**TOWN OF NEWBURGH  
PLANNING BOARD  
TECHNICAL REVIEW COMMENTS**

**PROJECT: PEAK SUMMIT SUBDIVISION**  
**PROJECT NO.: 16-13**  
**PROJECT LOCATION: SECTION 17, BLOCK 1, LOT 40.2**  
**REVIEW DATE: 23 AUGUST 2016**  
**MEETING DATE: 1 SEPTEMBER 2016**  
**PROJECT REPRESENTATIVE: ZEN DESIGN**

<b>ENGINEER</b> WILLIAM MOREAU, P.E.		<b>PEAK SUMMIT ENTERPRISES, INC.</b>	
		<b>3 LOT SUBDIVISION</b>	
		<b>LOT LAYOUT</b>	
		<b>FOSTERTOWN ROAD, SBL: 17-1-40.2</b>	
		<b>TOWN OF NEWBURGH, ORANGE COUNTY, NY</b>	
DATE	SCALE	JOB NUMBER	SHEET NUMBER
07/30/2016	1" = 50'	15-035-KAL	2 OF 4

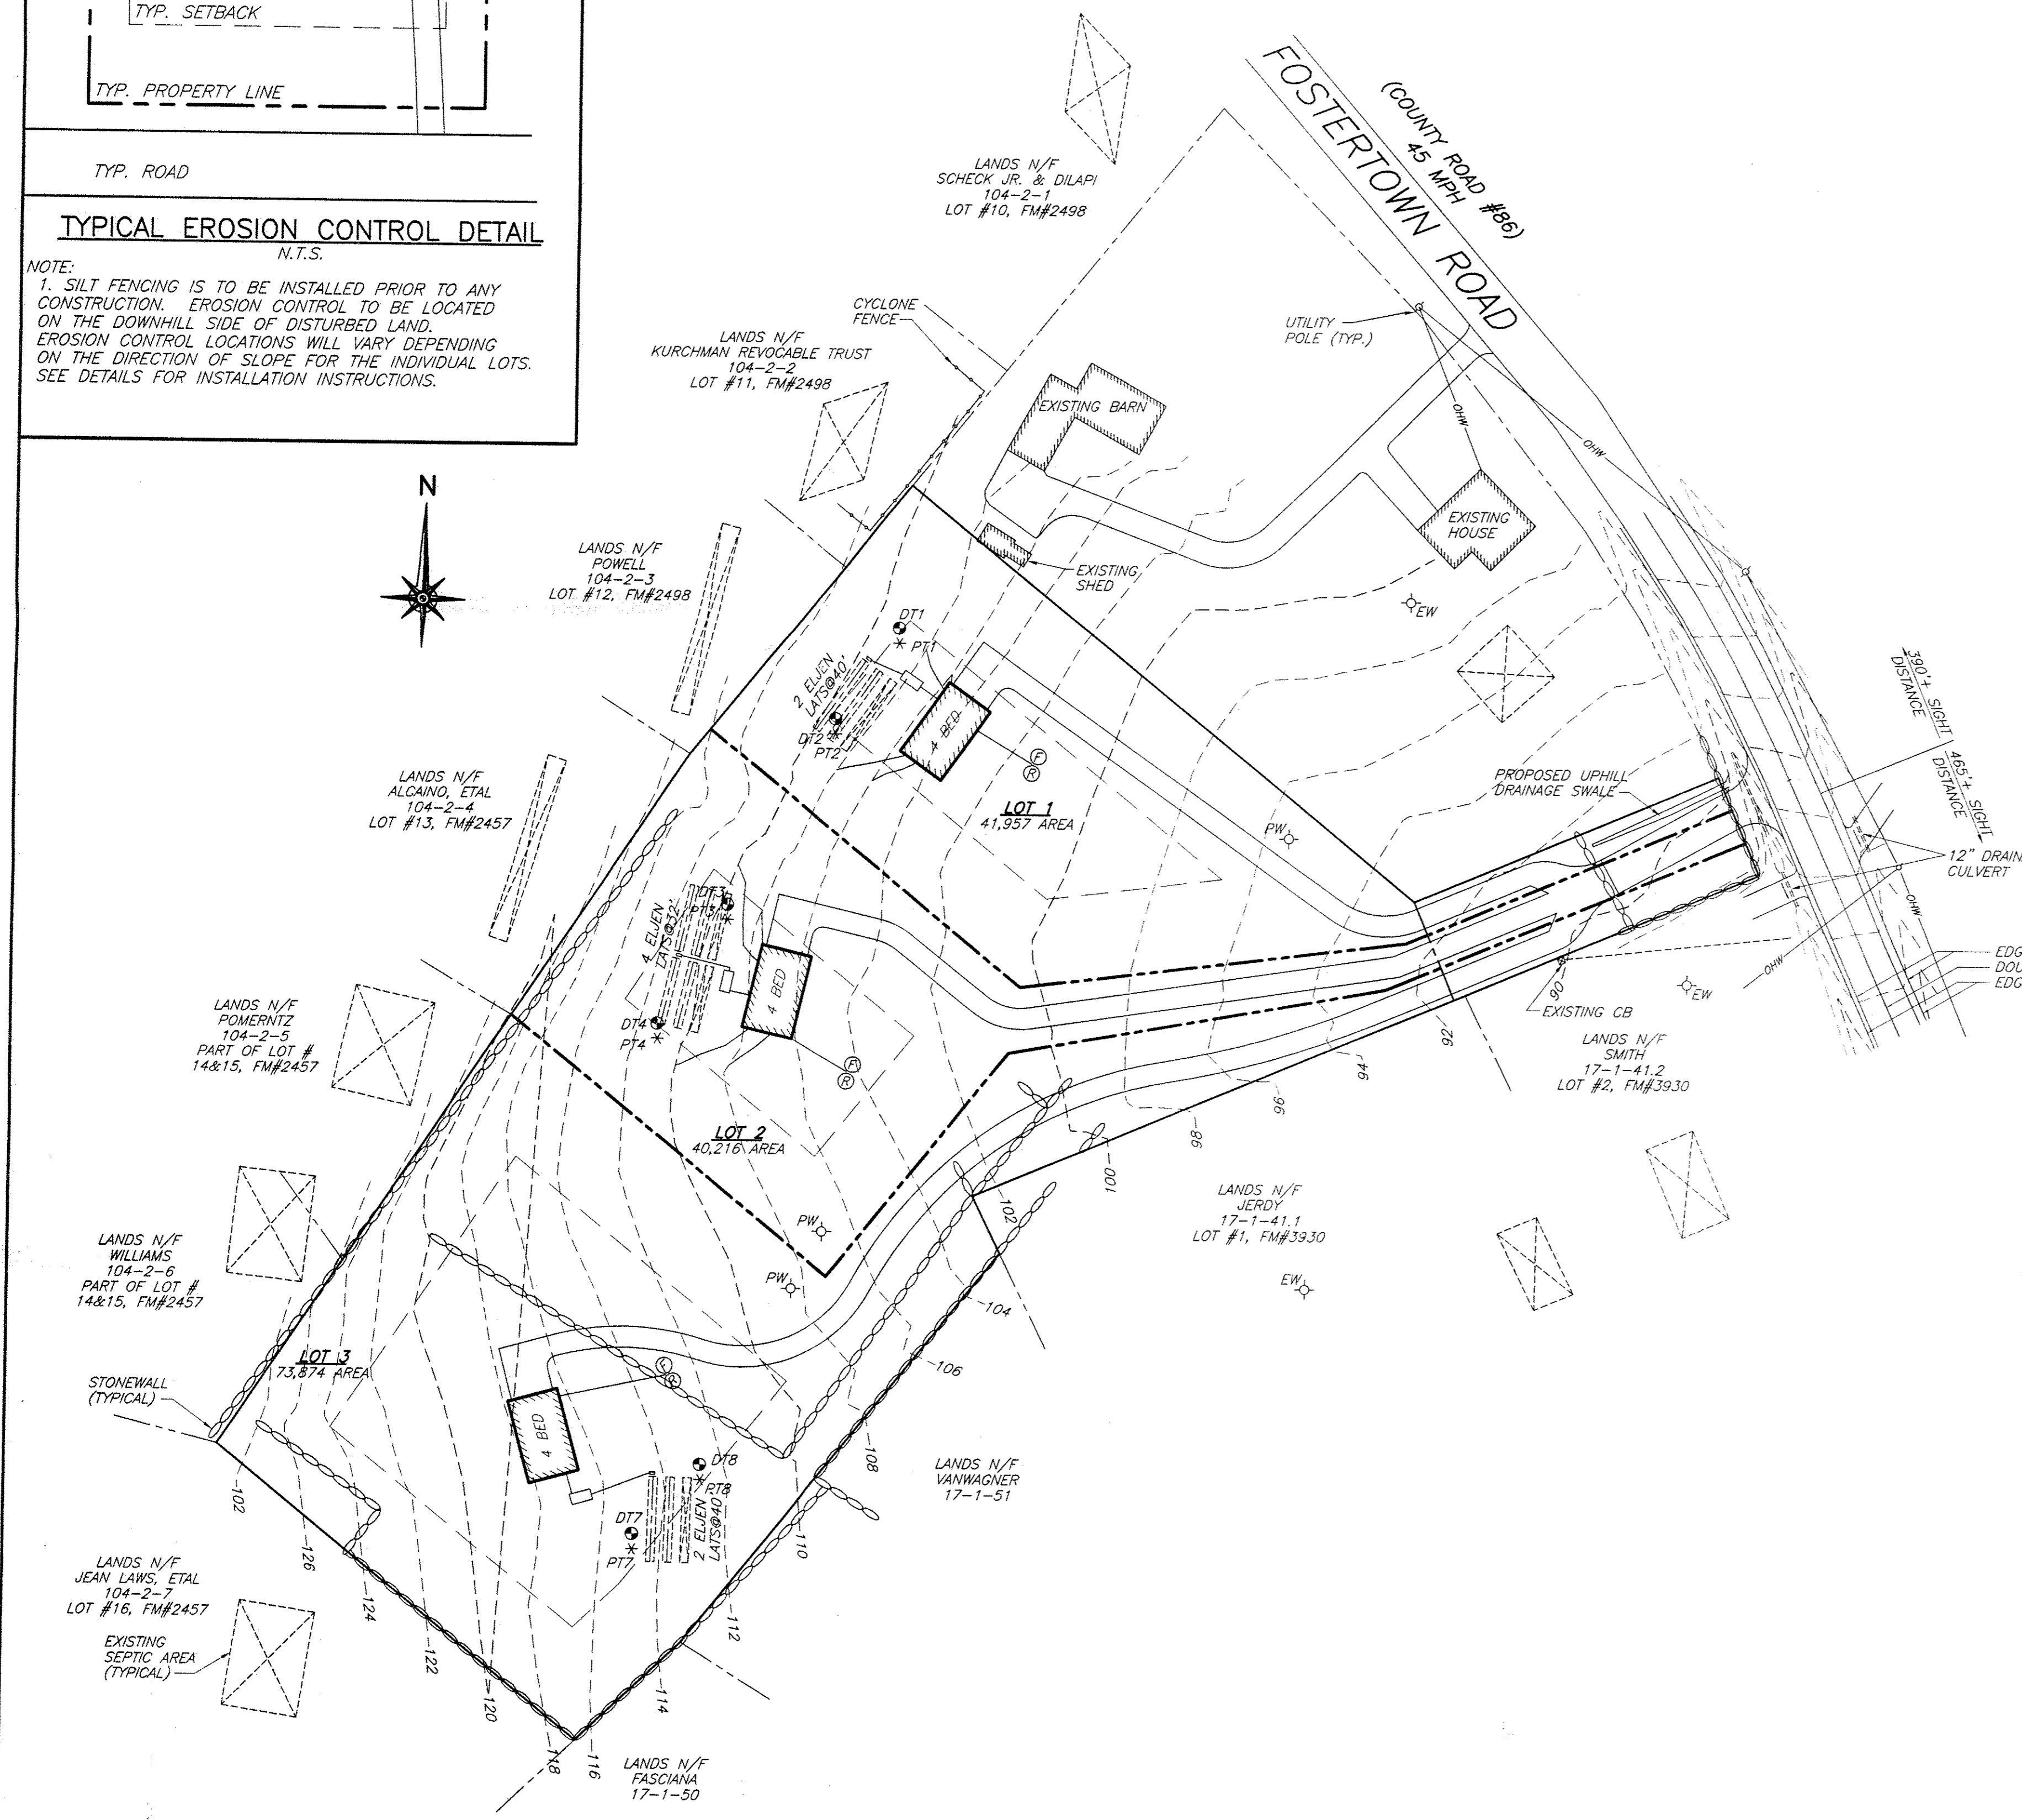
4. Lowest sewer elevations should be depicted on the plan sheets. Two of the lots have the sanitary sewer systems located behind and up gradient of the residential structures.

5. All adjoining wells should be depicted on the plans to assure adequate separation distances.
6. Limits of disturbance and calculated area of disturbance should be provided to determine if SWPPP is required.

9. Common driveway access and maintenance agreement for that portion of the shared driveway is required to be submitted to Mike Donnelly's office for review and approval.
10. Check the 120 contour across proposed lot #3, there appears to be an added line.
11. Label separation distances between wells and septic, utilizing radius lines.

**COUNTY DRIVEWAY ENTRANCE**  
N.T.S.

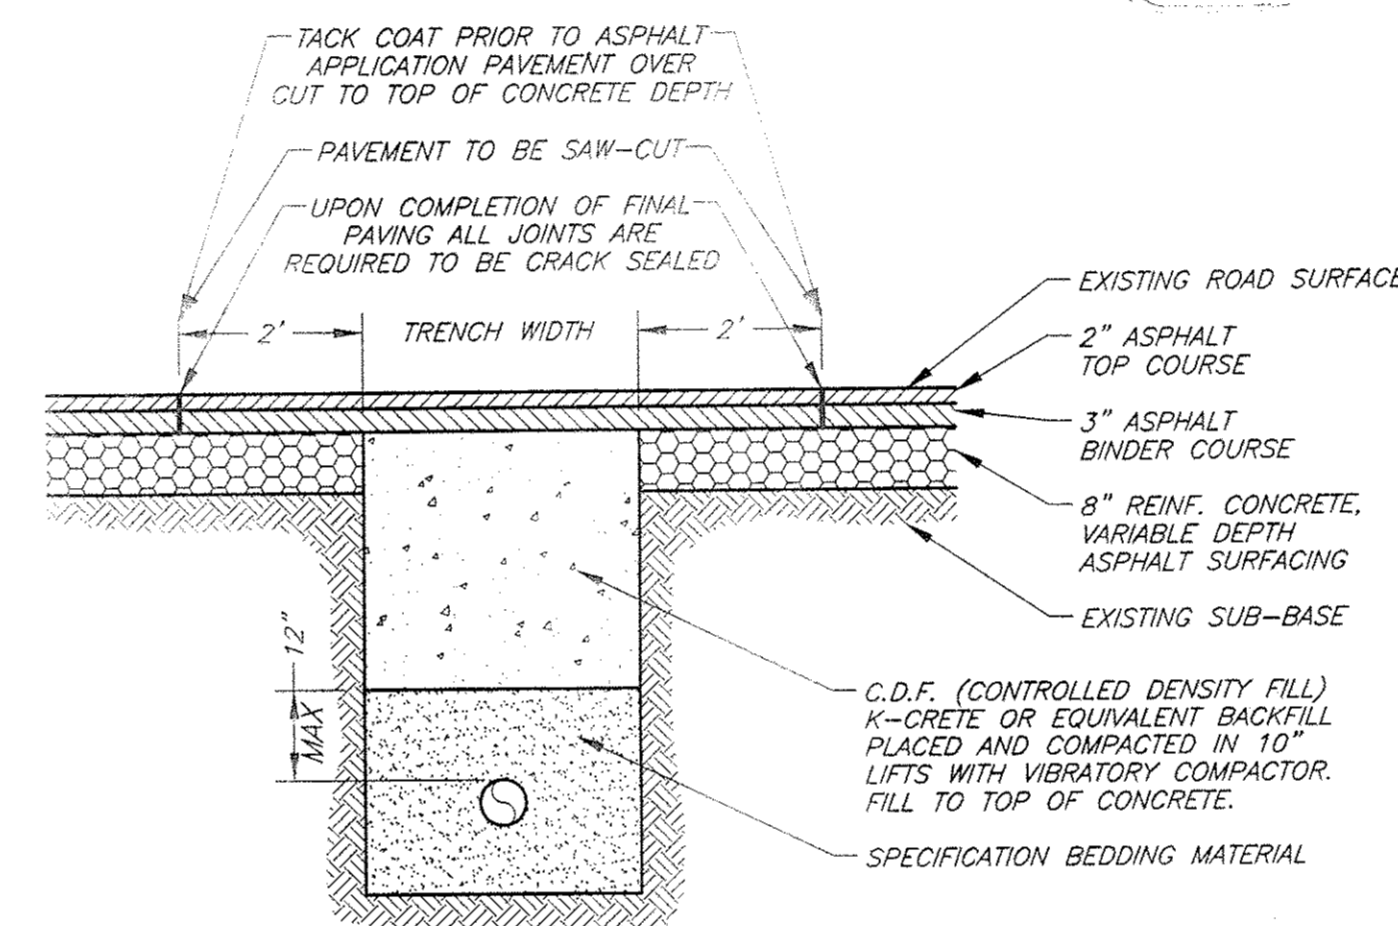
7. Pipe size at county driveway crossing should be depicted.
8. Source of topography depicted on the plans should be identified in survey notes.

**TYPICAL PLAN VIEW (ELJEN SYSTEM)**  
 N.T.S.

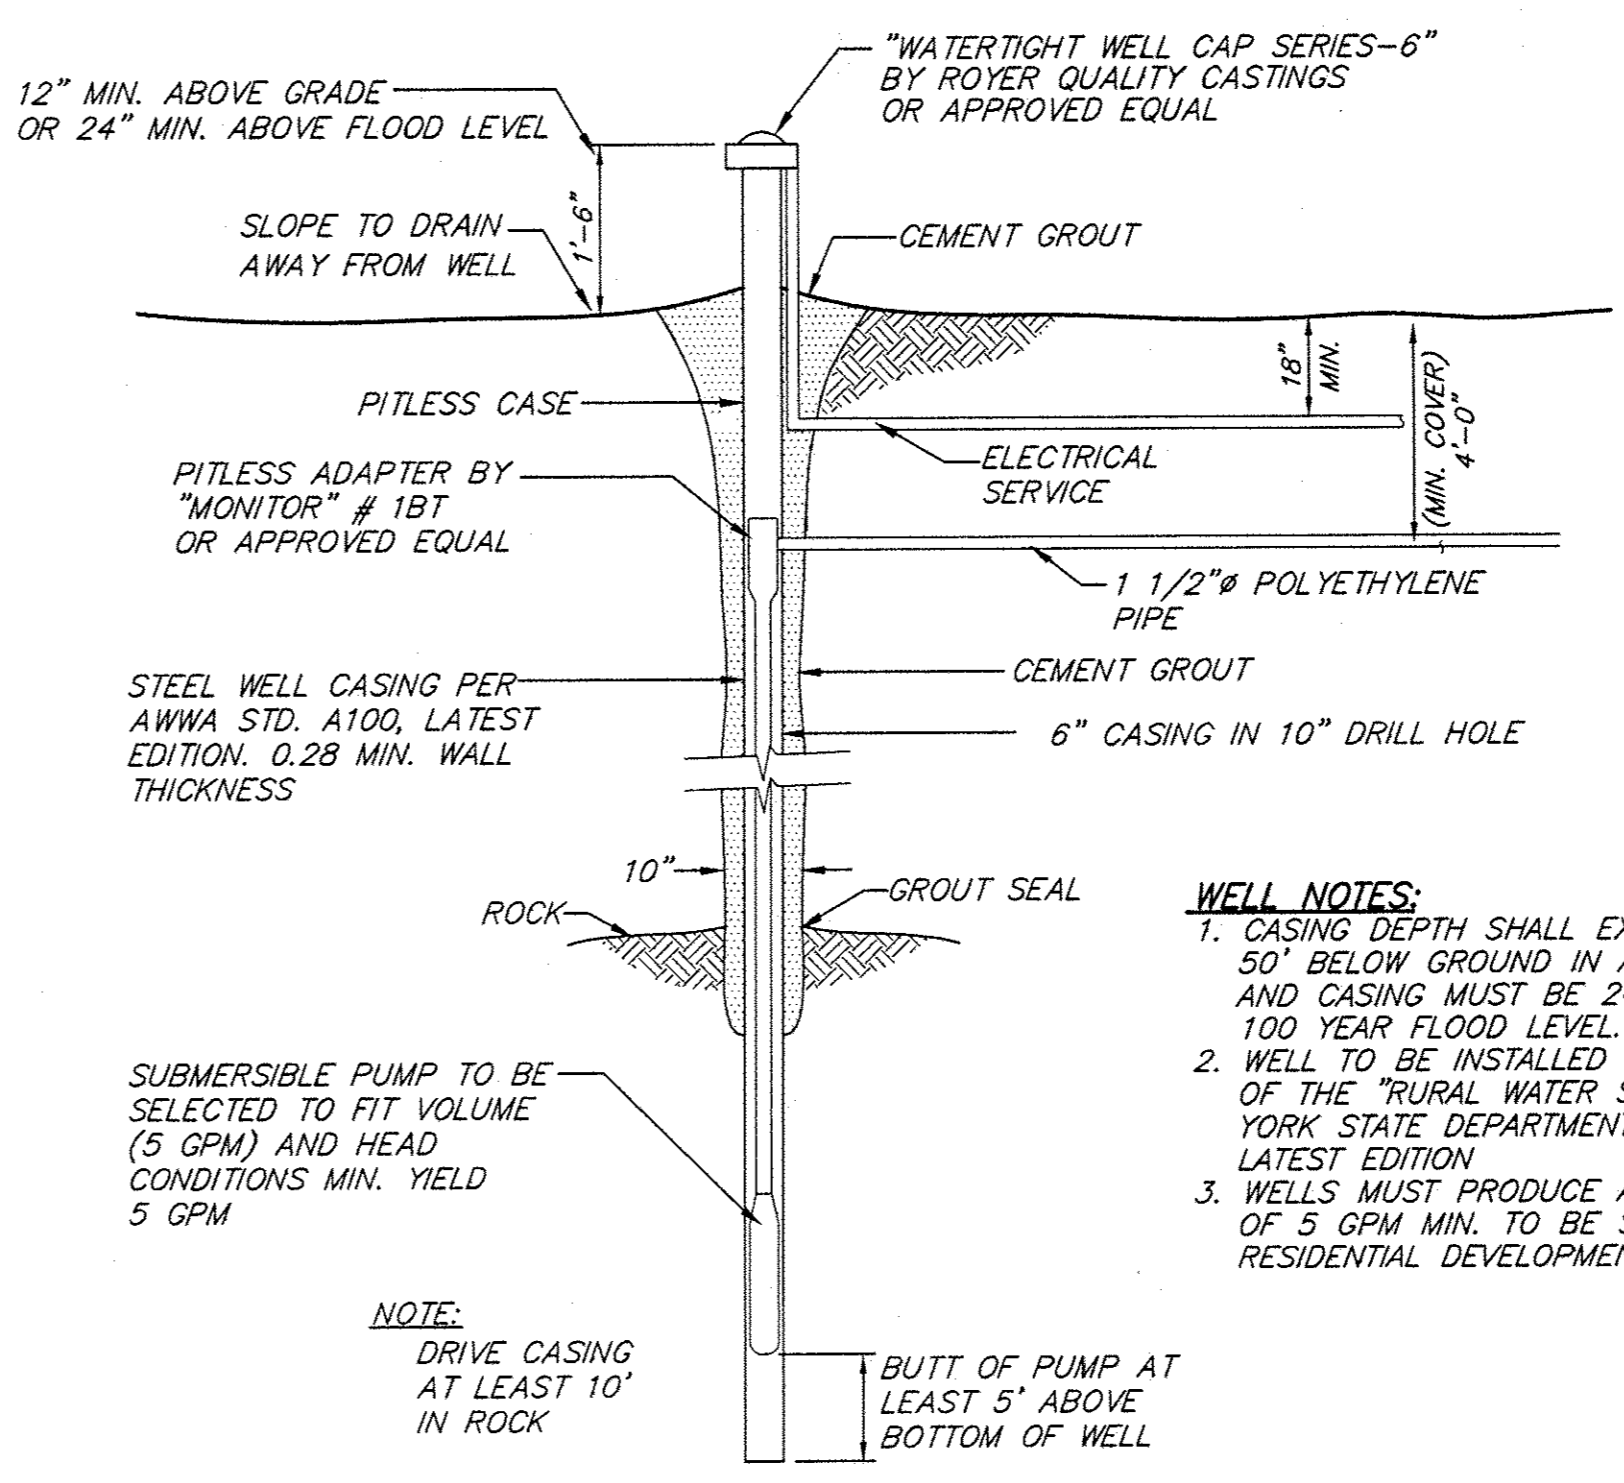
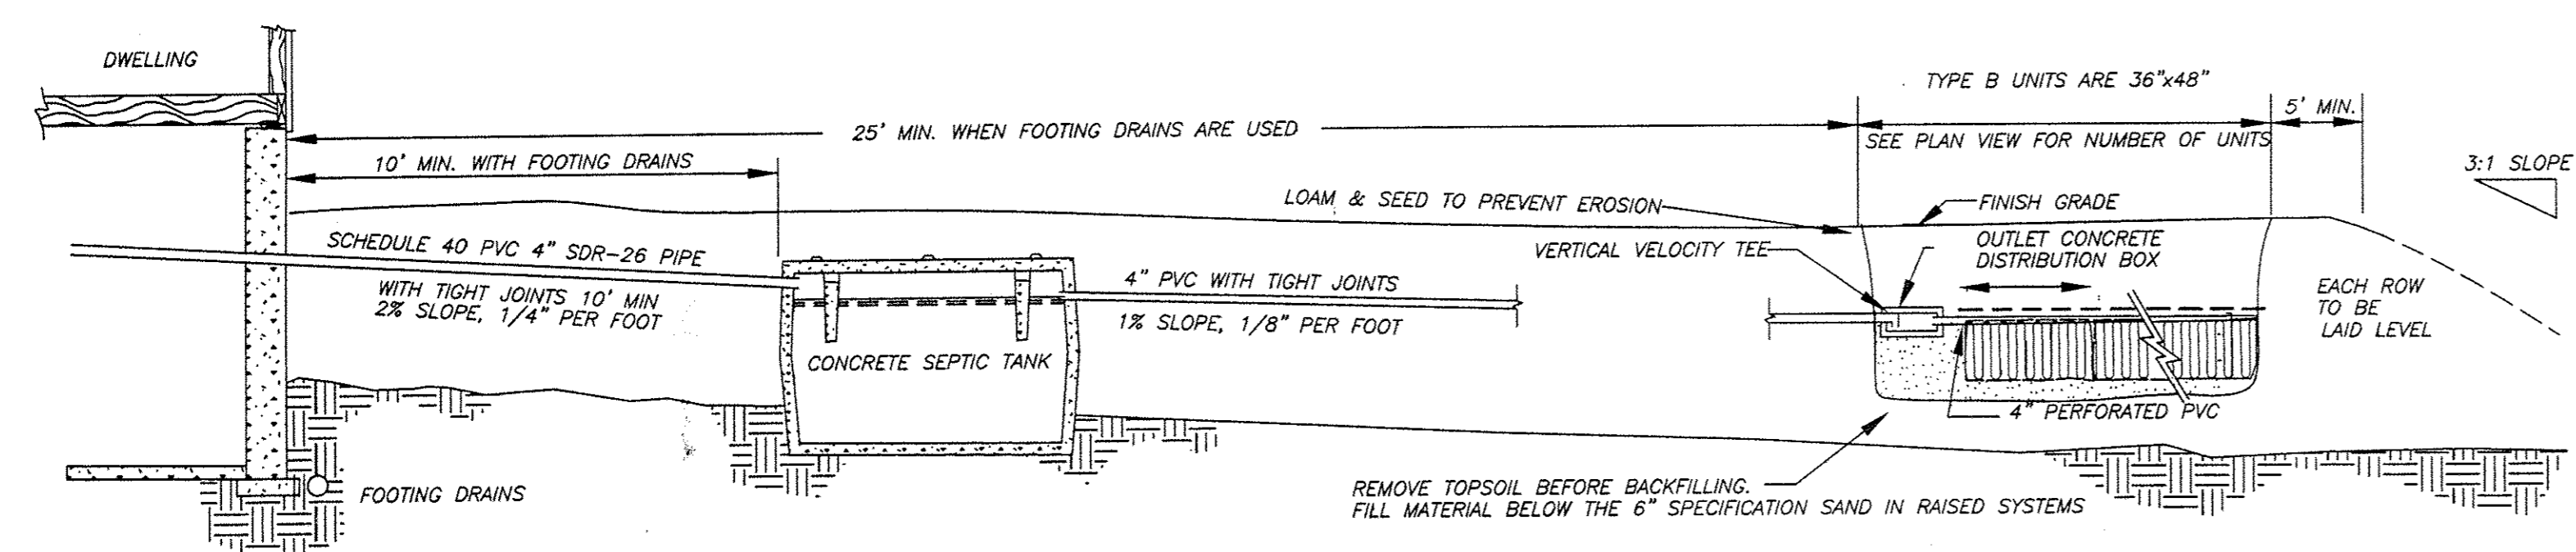
3. Septic design table identifies in ground systems while detail sheet contains what appears to be shallow absorbent trench systems. Shallow absorbent trench notes appear to conflict with elgen system details in some locations. An example being "field shall be 10 feet beyond edge of trenches before starting one on three" detail depicts 5 feet. Septic system should be coordinated between detail sheets, design notes, etc.
